Title 40°/35.1° SPROCKET EAVES DETAILS (STANDARD)

ADN - RSD - Scale at A4 1:10 Revision B Reference F-SD0565

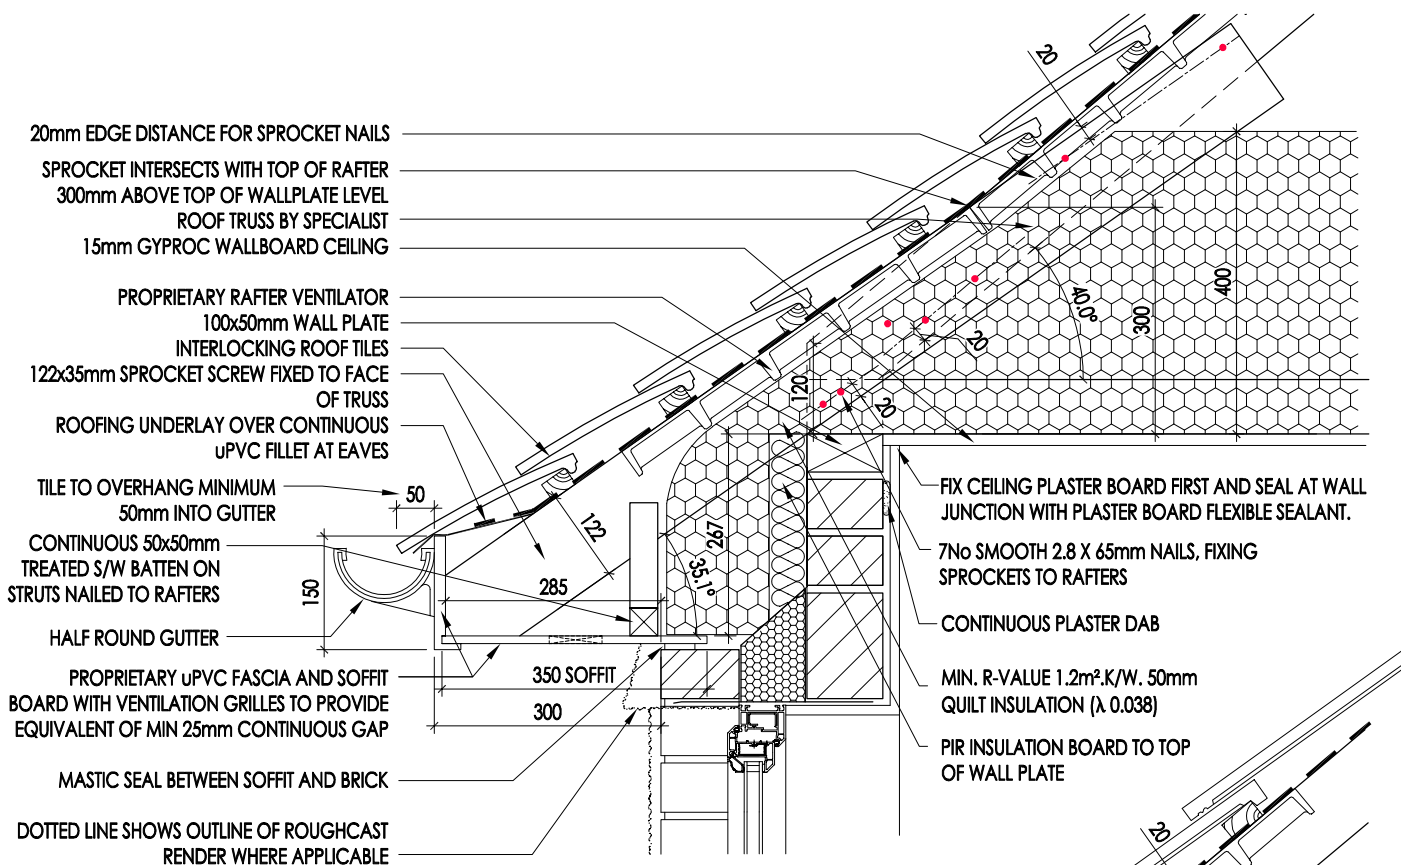
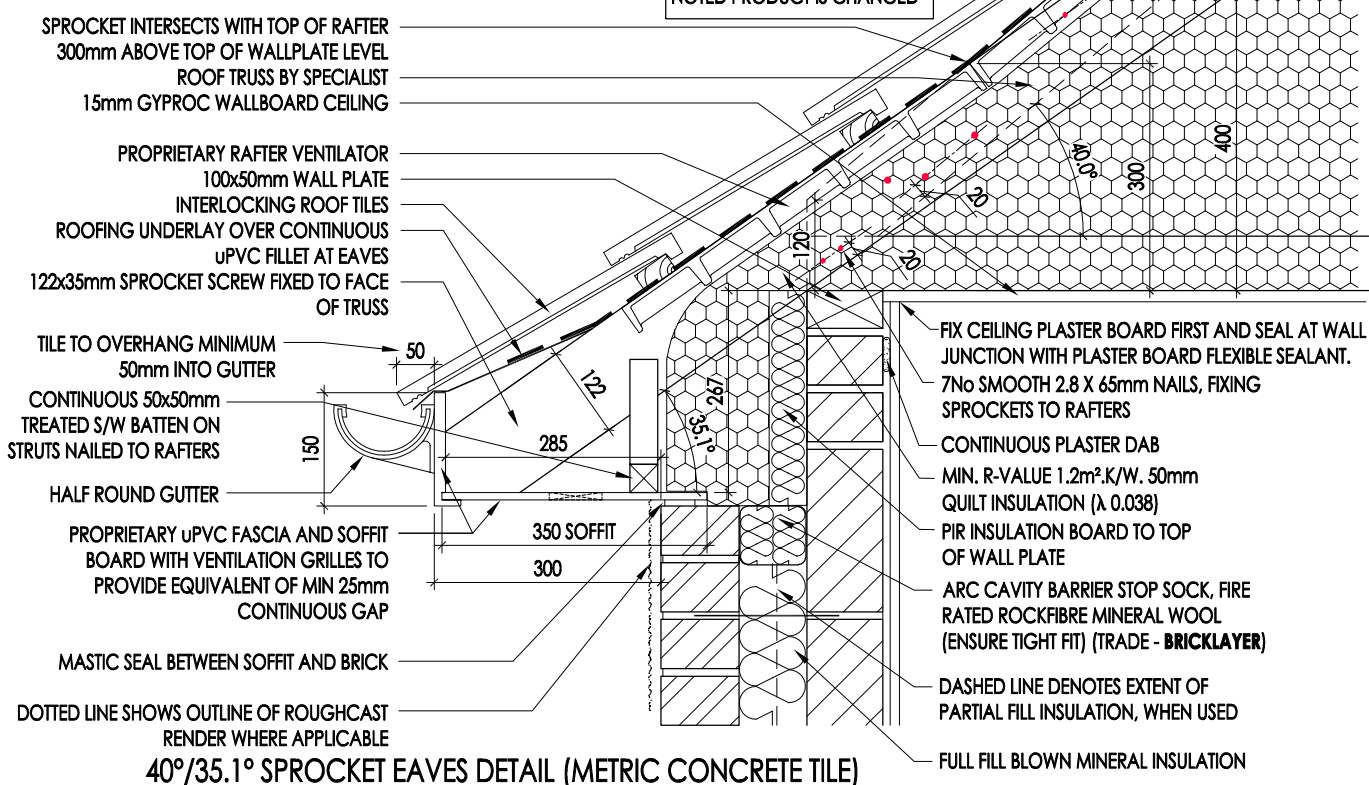
B 07.09.21 PIR insulation to top of wall plate added.

A 13.08.19 Nail location & edge distance added to hip joint (sprocket fixing). Rigid insulation above cavity stop removed, cavity wall shown to bottom detail. Full fill blown insulation shown.
